**BUILDING APPLICATION
PLAN REVIEW COMMENTS**

Application #: PB12-09253
Status: APPROVED
Date Submitted: 10/17/2012
Date Issued:

Address: 11477 WOODLAND SPRINGS DR
Parcel ID: T0973401 Zoning: E
Addition: WOODLAND SPRINGS PLAZA Lot / Block: 1 /A
Legal Desc: WOODLAND SPRINGS PLAZA BLOCK A LOT 1A
Description of Work: RETAIL/INTERIOR FINISHOUT/SUITE #130
ADA TDLR#: Energy Code
Compliant:

SCOPE OF WORK: FINISHOUT OF EXISTING SPACE---
RESTROOM-MECHANICAL; ELECTRICAL AND PLUMBING WORK---- NEW
DROPPED CEILING
+++
PLANS BY GEORGE H. WANG--- TEXAS P.E. reg. # 45134
===
Breathing Zone Outdoor Airflow -2009 International

PLUMBING FLR PLAN

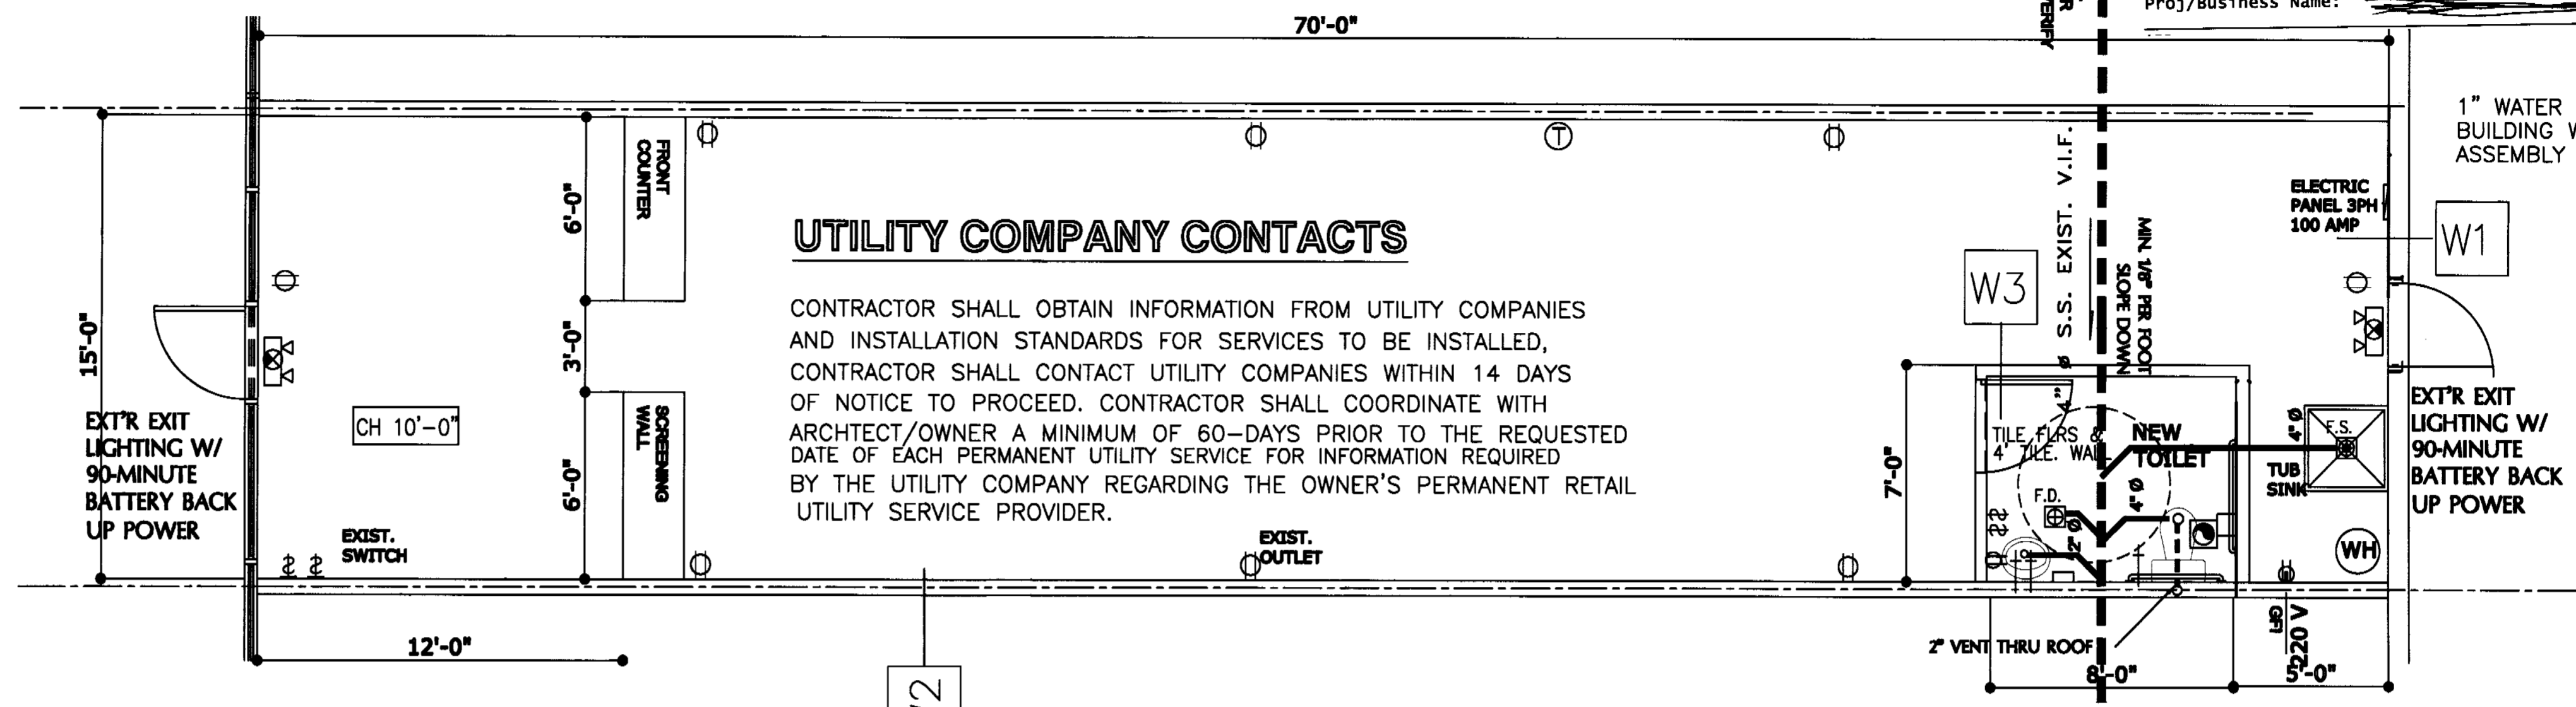
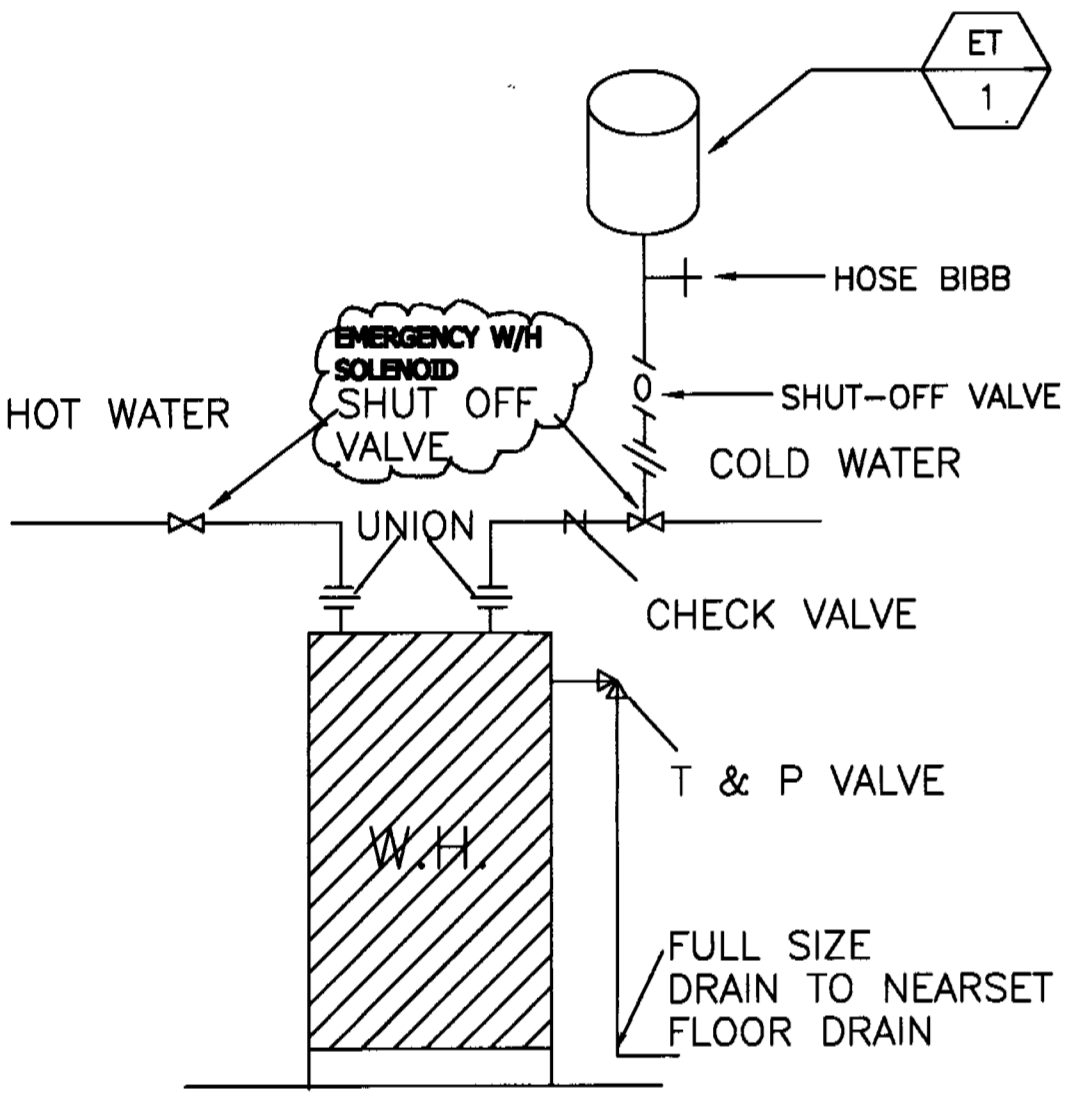
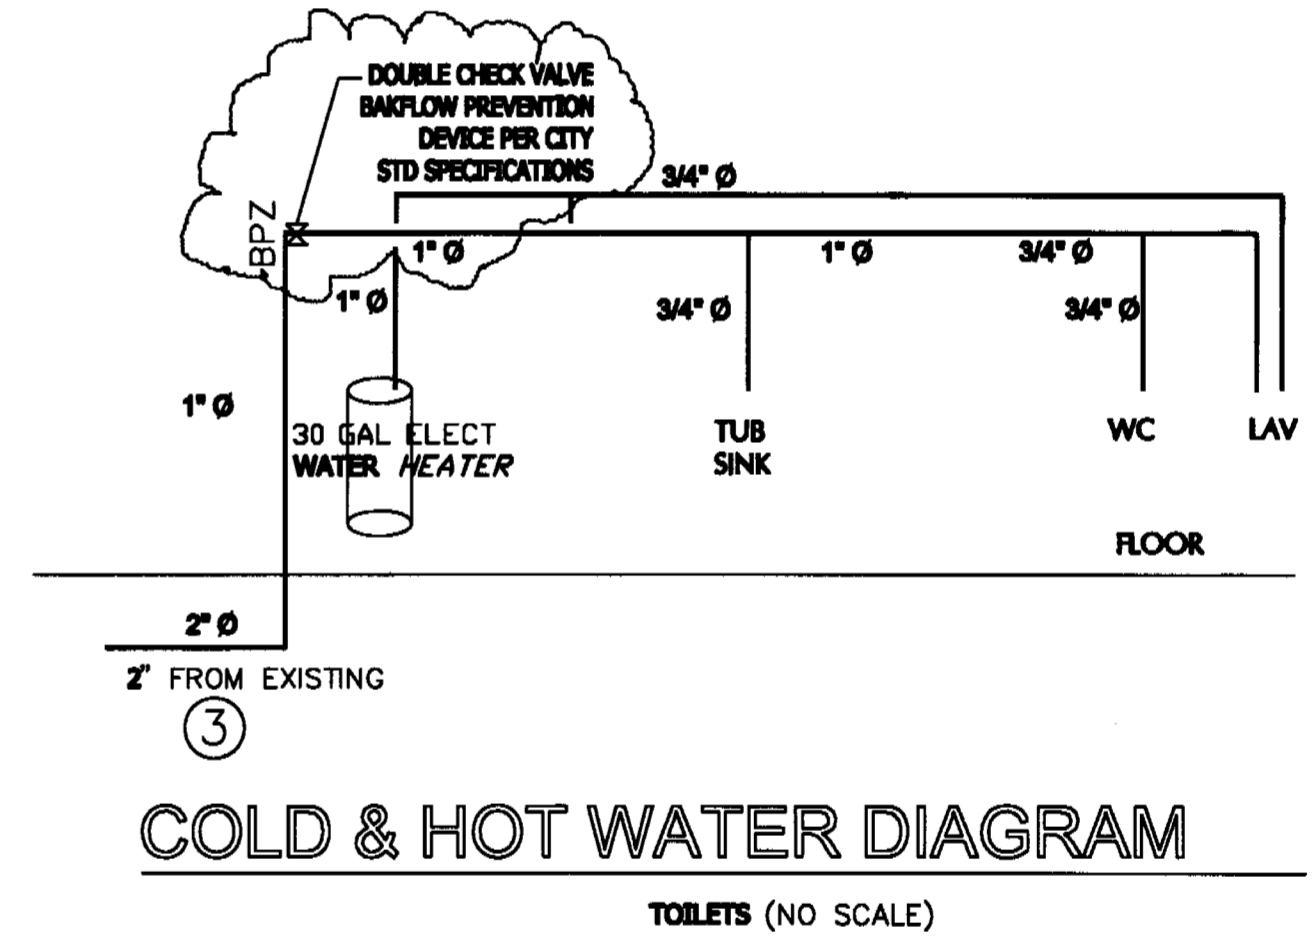
-revised-----10-17-12----HOLD --- Plumbing sheet ,
shows that construction will comply 2003 and 2006
---International Plumbing Codes.

Please provide two copies of Plumbing plans showing
compliance with 2009 International plumbing codes. - signed
by p.e. of record.

10-19-12---HOLD--- REVISED PLANS SHOW CORRECT CODE DATA

PLUMBING DESIGN BASED UPON INTERNATIONAL PLUMBING CODE 2009.

H.V.A.C. FLOOR PLAN

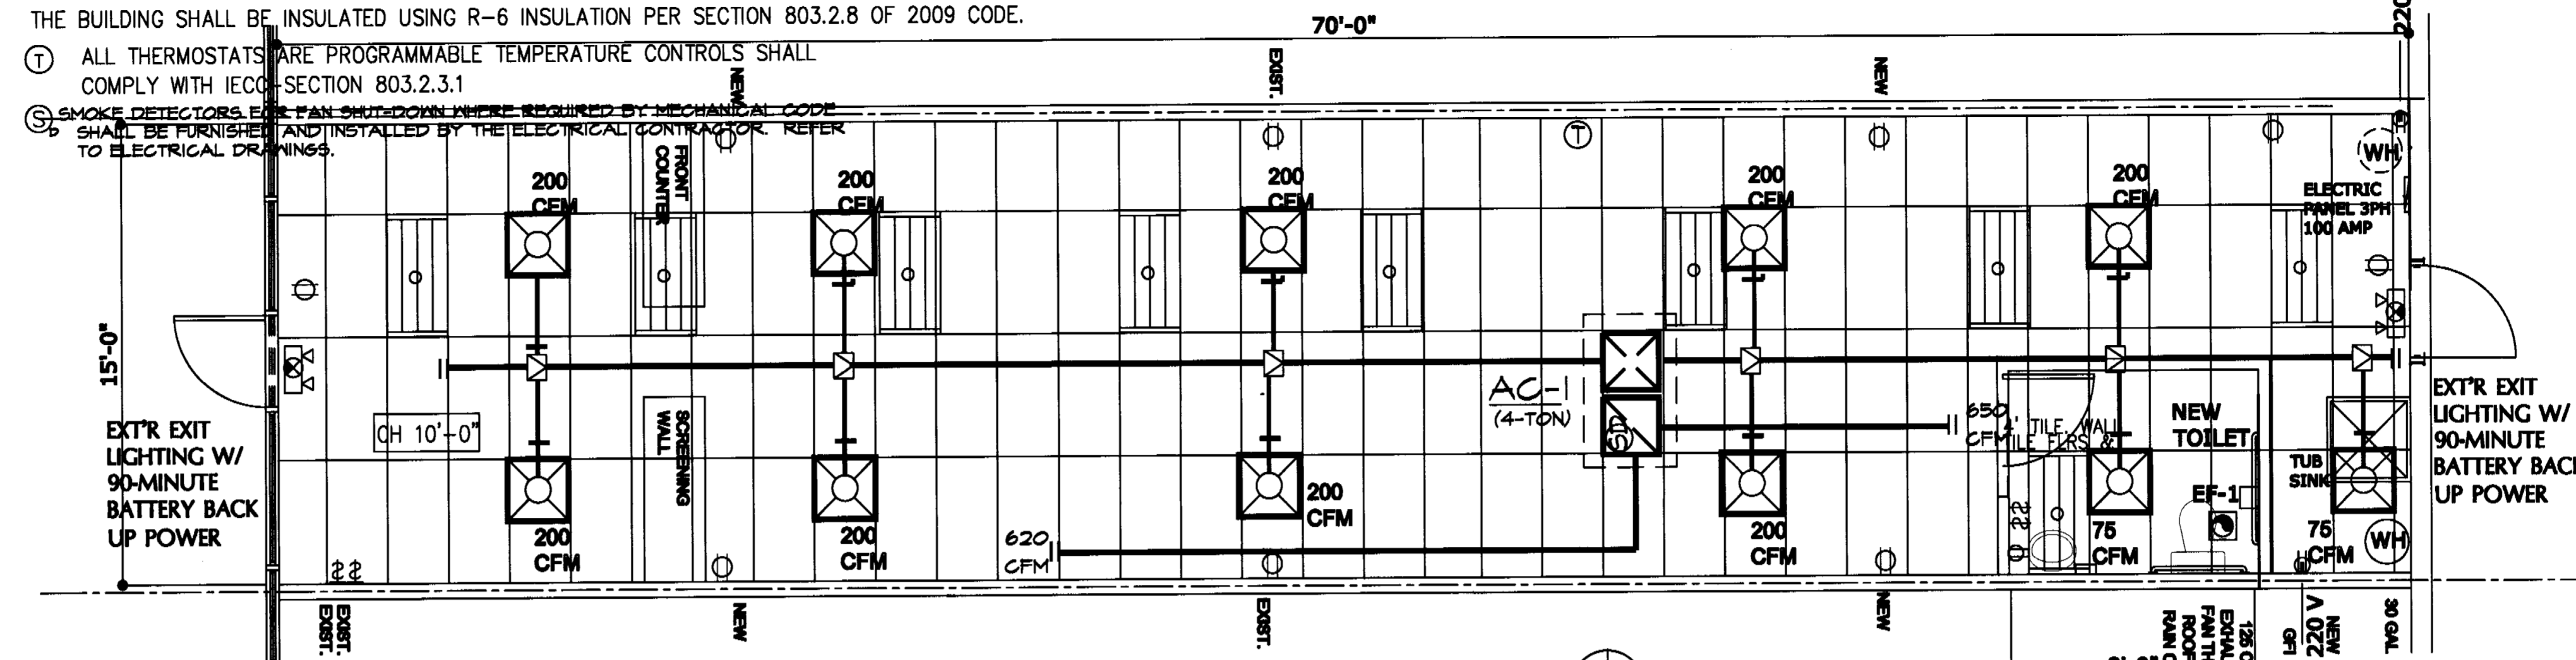
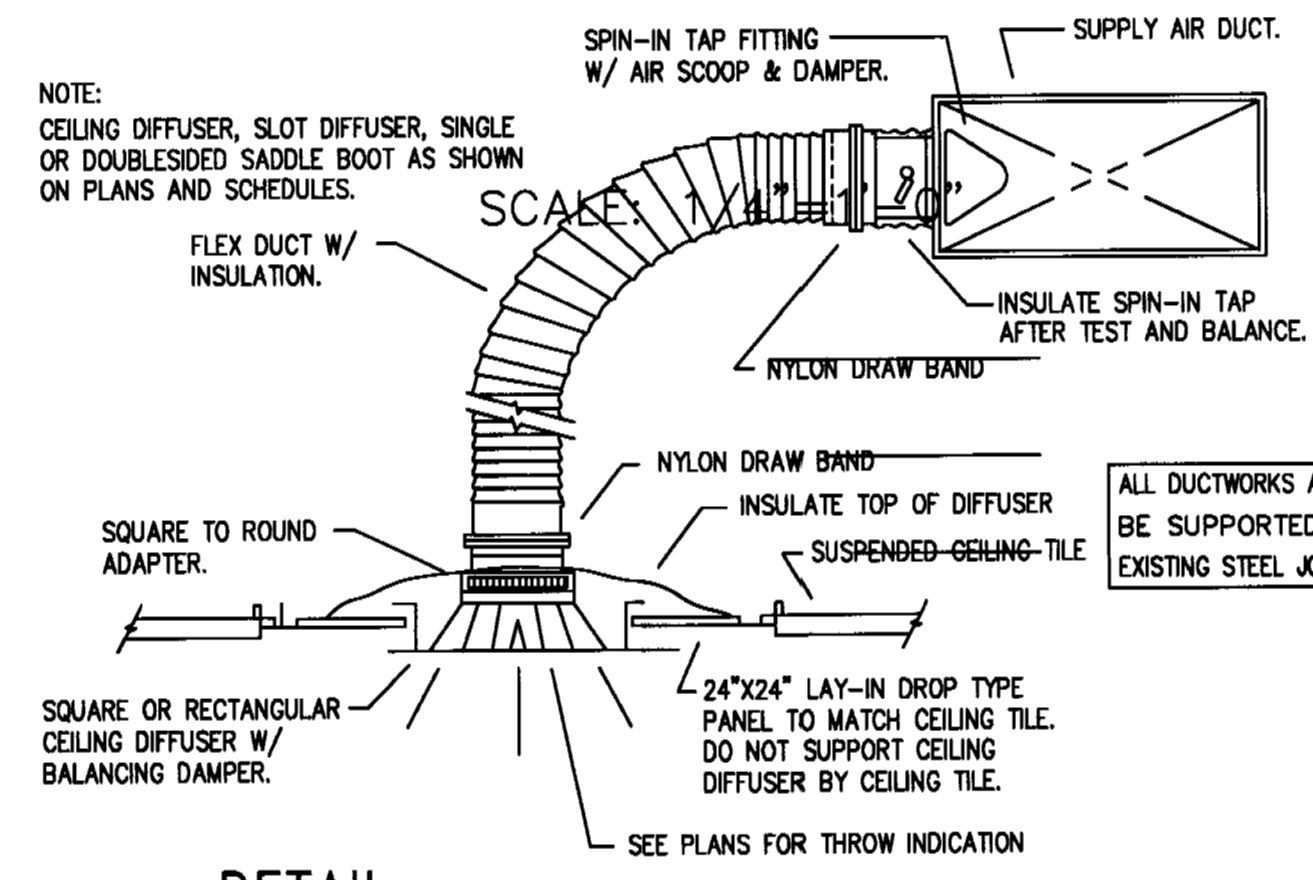
rev-ssed-----10-17-12---HOLD---- Mechanical sheet is
Incomplete; does not shown Outside air requirements for
Retail use.

Breathing Zone Outdoor Airflow -2009 International
Mechanical Code -Section 403.3
The outdoor rate required to supplied in the Breathing zone
[V/ bz] of the occupiable space or spaces in a zone shall
be determined in accordance with Equation 4-1

$V / bz = R/p \times Pz + R a \times A z$ ----- equals 244 C.F.M

Please provide two copies of Mechanical plans showing
compliance with outside breathing air.

MECHANICAL SCHEDULE SHOWS ----- 320 C.F.M PROVIDED

APPROVAL SUBJECT TO FIELD INSPECTORS VERIFICATION

10-19-12---APPROVED

$V/ bz = R/p \times Pz + Ra \times Az$ ----- equals 244 C.F.M. OUTSIDE AIR Required
 MECHANICAL SCHEDULE SHOWS ----- 320 C.F.M. PROVIDED
